HOWARD COUNTY HISTORIC PRESERVATION COMMISSION

May Minutes

Thursday, May 4, 2017; 7:00 p.m.

Figure 10 - Amended deck plan

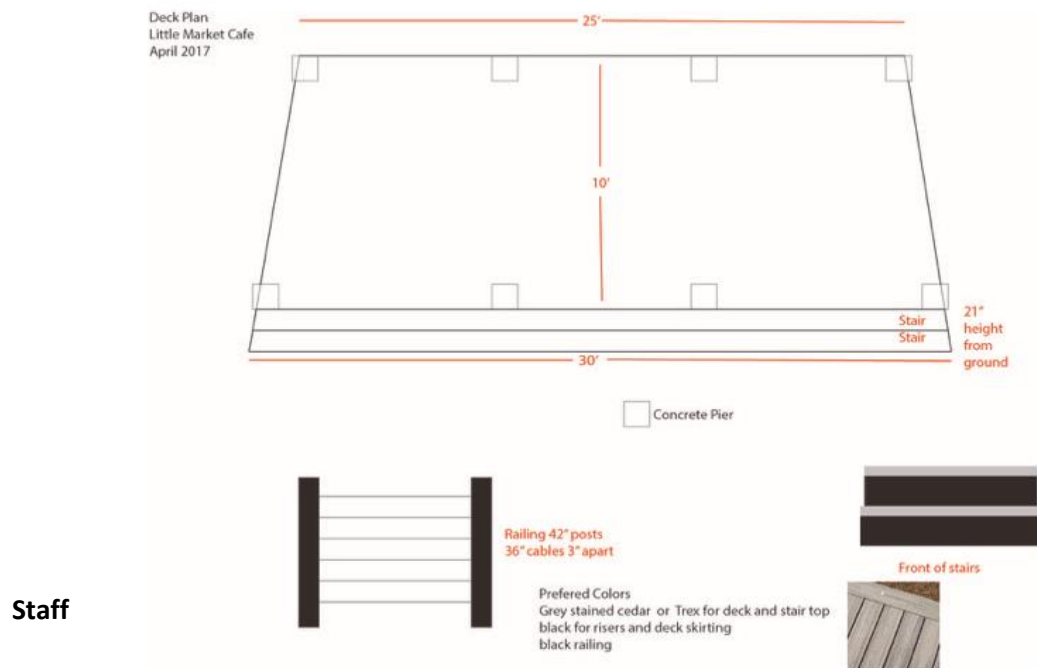
Comments: This request is not for a typical deck, as it is not for a residential structure and it will be visible from the public right-of-way. Staff finds the proposal should be evaluated as street furniture, given the commercial location and purpose of the proposed deck. The proposal complies with Chapter 10.C of the Guidelines, which recommends, “use street furniture that is simple in design and constructed of traditional materials such as wood and dark metal” and “particularly along the commercial section of Main Street, place street furniture in areas where the sidewalk is wider or where adjacent public open space (such as the plaza next to the railroad museum) provides a more spacious public environment.” The proposed deck will be located in the private courtyard along Tonge Row, in an area where there is a more spacious environment, as recommended by the Guidelines. Staff finds the proposed use of Trex does not comply with the Guidelines.

Chapter 7.B of the Guidelines deals specifically with the construction of new porches and decks and recommends that they be “simple in design and should not alter or hide the basic form of the building.” The proposed deck will be detached from the building and is more of a landscape feature/patio for the commercial use of the area.

Staff discussed this application with the Department of Inspections, Licenses and Permits as this portion of the property appears to be in the floodplain. The deck may not be able to be constructed because of this, but if it is allowed, will be required to withstand certain flood velocities.

Mr. Reich said that Mr. Rodgers may run into code requirements for railings. Mr. Rodgers said the rails would be on the back of the deck and the two sides. The steps on the building side would run across the entire front. Mr. Rodgers said that there are only two steps and generally, if the height is three steps high or more, then hand railings are required. Mr. Rodgers said they will do what is needed in order to comply.

Ms. Tennor asked for elevations of the railings. Mr. Rodgers said he had a photo of the railing on his phone to show the Commission. Mr. Taylor asked Mr. Rodgers to email the photo to Staff first. The photo showed a modern design with cable railings. Ms. Tennor asked why such modern design was selected for the Historic District. Mr. Rodgers said it was chosen as an alternative to the standard County railing to blend well with the black rails. Ms. Porter said the cable railings gives transparency allowing patrons to look out and see the surroundings. Ms. Tennor said the railings are more modern compared to existing railings in the Historic District. Mr. Rodgers said they would be open to other railing ideas that would be more in line with the Historic District, such as the fence recently installed at the Sweet Elizabeth Jane store. Ms. Holmes said due to the last minute details of the application, the Applicant can always return for a later application for the railing.

Mr. Shad said he agreed the proposed railing was too modern and for the Applicant to use a more standard railing already in the Historic District.

Staff Recommendation: Staff recommends Approval contingent upon approval from the Department of Inspections, Licenses and Permits and the Department of Public Works, and that cedar wood should be used. Staff recommends Denial of Trex decking and stairs.

Motion: Mr. Reich moved to approve the application with the following changes: the railing will be changed to be similar to the railings at Sweet Elizabeth Jane and Staff will approve the details of the railing; the decking will be cedar wood stained Cape Cod gray; the deck structure will be made of a rough cut hemlock and will be exposed. Mr. Roth seconded. The motion was unanimously approved.

Figure 11 - Plans from 1989

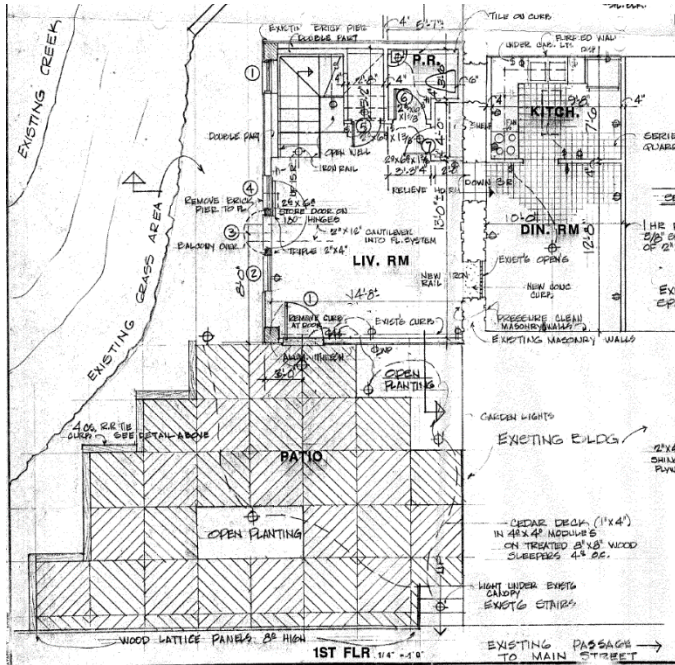
As seen in Figure 11, the plans from July 1989 were for a smaller deck than what was destroyed in the July 30, 2016 flood. At some point the deck was expanded beyond the original approval, which also did not include privacy walls.

Ms. Tennor asked about Staff's concern that the wooden deck was enlarged beyond the original proposed size. Dr. Taylor said the area where the deck was replaced with a concrete patio was the same footprint of the enlarged deck. Dr. Taylor said on the 1989 plan, the deck stopped at the back of 8173 Main Street and the deck was extended beyond 8181 Main Street. Beyond that the deck was a concrete patio which was destroyed during the flood. He explained that he had one uniform patio installed behind all four of the buildings.

Staff Recommendation: Staff recommends retroactive Approval as submitted for the work that has already been done to the stone wall, patio and rear addition. Staff recommends retroactive Approval of the enclosures of the doorways, the additional windows added to the building, and the switching of the door to a window. Staff recommends Approval of the proposed lighting fixtures. Staff recommends Denial of the proposed vinyl railing and board on board fence and barn door. Staff recommends an alternate railing and fence style, such as a black metal fence, be used.

Figure 15 - Location of proposed fence

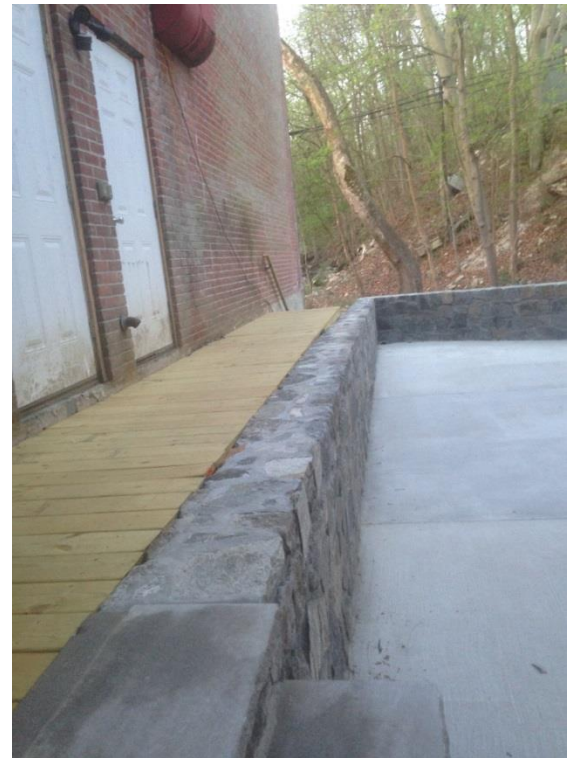
The Applicant proposes to install a wood board on board fence and sliding barn door along the wall shown in Figures 14 and 15 and a brown vinyl railing along the stairs shown in Figure 13 and 14. Staff finds this proposal uses too many materials and recommends simplifying the application to using a black iron or aluminum railing along the wall and staircase. There are several styles of simple black metal railings that have been used throughout town that would better complement the stonework on this patio than the wood board fence and vinyl railing. Chapter 9.D of the Guidelines recommends, “install open fencing, generally not more than five feet high, of wood or dark metal. Use closed wood fences only for side and rear yards in areas where a precedent exists. Construct closed wood fences of painted vertical boards, with straight or angled rather than scalloped tops.” Staff does not find a precedent exists for a closed board fence in this location and finds an open black metal fence would better complement the space and function in the same manner as the closed board fence. A privacy fence is unnecessary in this location as the patio looks to the side of a building and Staff was told by the Applicant that the patio would have no commercial use on it.

Mr. Reich said the Applicant will install a gate but if the gate is not allowable, the Applicant will install the railing and handrail recommended by Staff instead of the board on board fence and vinyl handrail. Ms. Burgess said a rail would be required regardless due to the height of the boardwalk above the patio to prevent people from falling.

Motion: Mr. Reich moved to approve the application as submitted with the following changes: that a black metal gate be installed in the alley and a black metal rail of 42 inches be installed along the edge of the raised platform/boardwalk and a black metal handrail installed on the stairway. The design of the hand rail and gate subject to staff approval. Mr. Roth seconded. The motion was unanimously approved.

Figure 22 - Plans from 1989

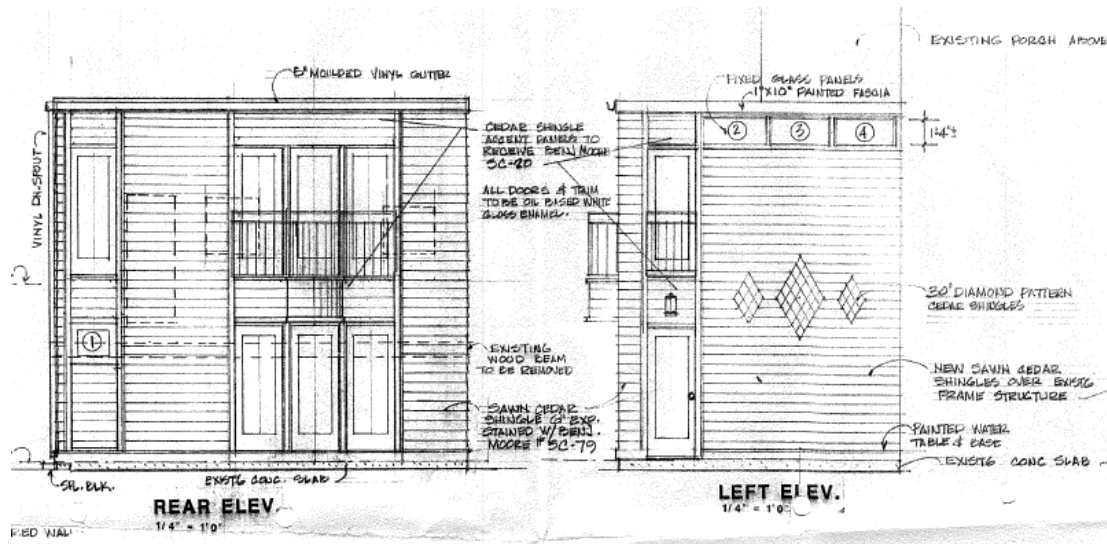
The Applicant has stated that the repairs to the rear were in-kind to match how the building has looked for the last 22 years, other than changing a door to a window for safety. The Applicant said the addition was most likely not built according to the approved 1989 plans. The rear addition, as seen in Figure 23, is modern in design and the alterations to the approved plans are not drastic. However, the entire side of the building has been resided and the two back door openings, including the second floor balcony, have been enclosed with cedar siding, reducing the openings. There should be three door spaces opening on to the deck, instead there are two. There should be the same three openings below the deck, instead there are two windows. While the details are slightly different, the symmetry remains the same and the integrity of the building is not affected by the changes. The side of the building has two windows that are not on the approved plans. The window above the door is supposed to be a door with a small Juliette balcony; however, the existing window is less intrusive. The paired windows to the right of the door are not on the drawings but match the other windows in design and style and do not detract from the building's integrity. The alterations comply with Chapter 7 recommendations for new construction additions.

Figure 30 - Existing conditions

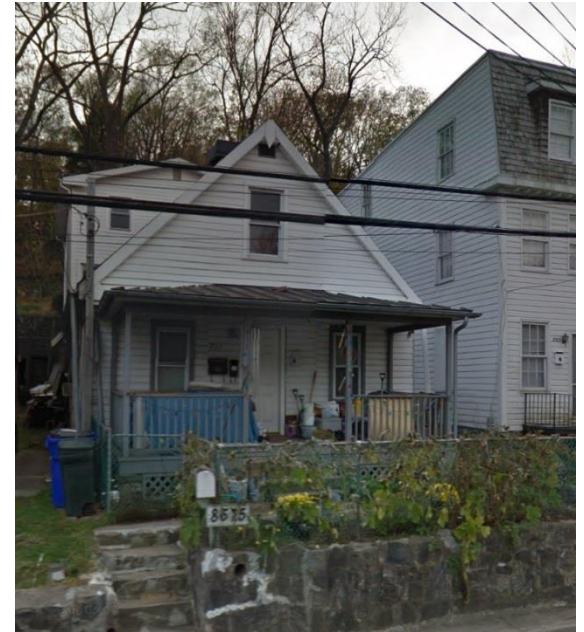
The existing roof is not historic and is already an asphalt shingle. The proposed replacement roof complies with Chapter 6.E recommendations, “...use asphalt shingles that are flat, uniform in color and texture and of a neutral color.” The porch roof is a metal roof and the Applicant said they are not proposing to replace it.

The application indicates that the current windows on the house are a mix of vinyl and wood. The Applicant proposes to replace all of the windows on the front portion of the house with wood Pella windows painted white. As mentioned in the case history above, the photographs and elevations from 2001 and 2004 show that the historic windows on the building have been removed without approval, and the window openings on the front and side appear to have been filled in with smaller windows inserted in the new openings. Chapter 6.H of the Guidelines recommends, “replace inappropriate modern windows with windows of appropriate style. If documentary evidence of the original windows is available, choose new windows similar to the original. Otherwise, select windows appropriate to the period and style of the building” and “restore window openings that have been filled in, using physical, pictorial or documentary evidence to accurately restore the building’s historic appearance.” Chapter 6.H of the Guidelines recommends against the changes that were done to the original windows. Staff recommends the windows be replaced with 6:6 windows, to match the windows that were removed without approval, and that the window openings be restored to the proper size on the front and side of the front portion of the building.

- 1) Staff recommends the windows on the front portion of the house be replaced with 6:6 wood windows to match the windows that were removed without approval, and the size of the window openings be restored to the original size.
- 2) Staff recommends wood siding be used on the front façade of the house and HardiePlank be used on the sides of the front portion of the house, as approved by the Commission in 2007.
- 3) Staff recommends the HardiePlank be the smooth instead of the wood grain, as painted wood siding does not have a wood grain.
- 4) Staff recommends Approval of the replacement roof as submitted.

- 5) Staff recommends the existing gutters in working condition be reused and new half round gutters and downspouts be added as needed.
- 6) Staff recommends Denial of K style gutters and downspouts, which are not historically appropriate.

- 4) Approve the use of HardiePlank siding on the left and right sides of the front portion of the house and the use of either HardiePlank or wood on the soffits and fascia on the sides of the house. Any trim on the front of the house would be replaced with real wood products.

Figure 37 - Current proposal

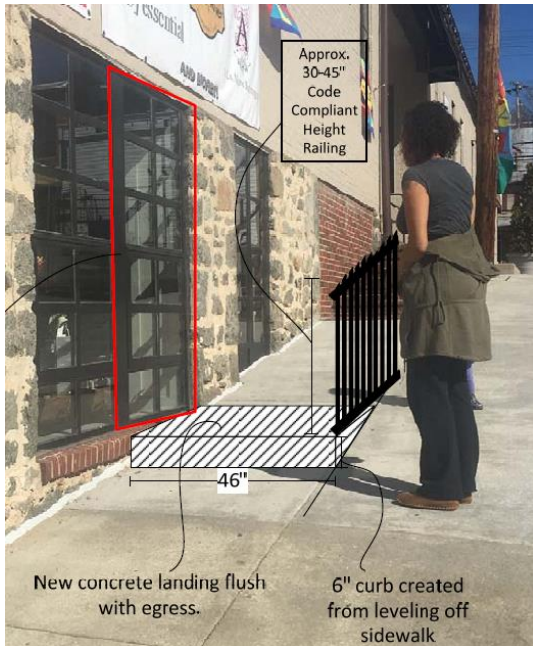
Ms. Zoren explained that originally she had discussed with Ms. Holmes the possibility of tapering the concrete to eliminate the railing. Ms. Holmes said she reviewed that idea with DILP, but they determined that tapering the concrete would require for more concrete work to be added to the sidewalk, disturbing the façade of the building. Ms. Holmes said the existing configuration was the most feasible allowing for easier removal of the concrete in the future if needed.
